March 29, 2016
L-2016-064
10 CFR 50.90

Re: Turkey Point Units 3 and 4
Docket Nos. 50-250 and 50-251
Response to Request for Additional Information Regarding
License Amendment Request No. 237, Application to Revise
Technical Specification Figure 3.1-2, Boric Acid Tank Minimum Volume

**Response to Request for Additional Information Regarding
Turkey Point Units 3 and 4 License Amendment Request No. 237:
Application to Revise Technical Specifications Figure 3.1-2,
Boric Acid Tank Minimum Volume**

Figure 4.1: Elevation view of typical boric acid storage tank (not to scale—Reference 2.18)

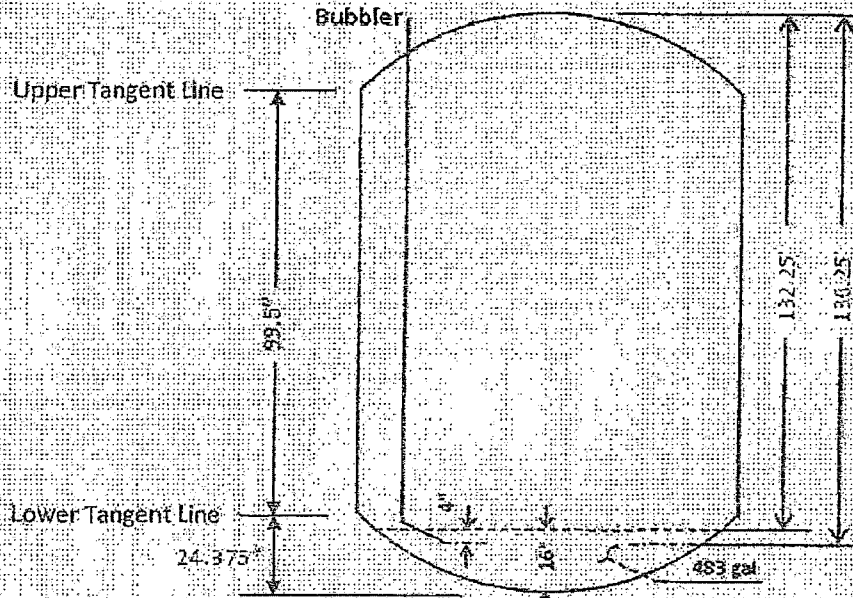
Because all three BASTs are interconnected creating a common tank, the staff requests information regarding the relative elevations of the BASTs.

Is the tank interconnection at a level that does not affect the accuracy of the level measurement system?

The BASTs are interconnected with 3 inch pipes at the bottom of each tank. The vortex height of each tank is 16 inches. The bubbler tube outlet for the level instrumentation is 4 inches below the top of the vortex level. Therefore, the useable range has been established from 4 inches above the outlet of the bubble tube to the top of the tank. As such, the BASTs interconnection does not affect the accuracy of the level measurement system. An excerpt from Calculation 25489-000-JLC-BG-00001 has been included below to further illustrate the vortex height and the useable range of the BASTs.

- 4.1.5 The full height of the BASTs is 148.25 inches, and subtracting the vortex height (16 inches) the useable height of the tank is 132.25 inches. The bubbler tube outlet for the level instrumentation is 4 inches below the vortex level (References 2.2, 2.17 & 2.18). Therefore, the useable range is from 4.0 inches above the outlet of the bubble tube to 136.25 inches above the outlet of the bubble tube (i.e., 4"-136.25").
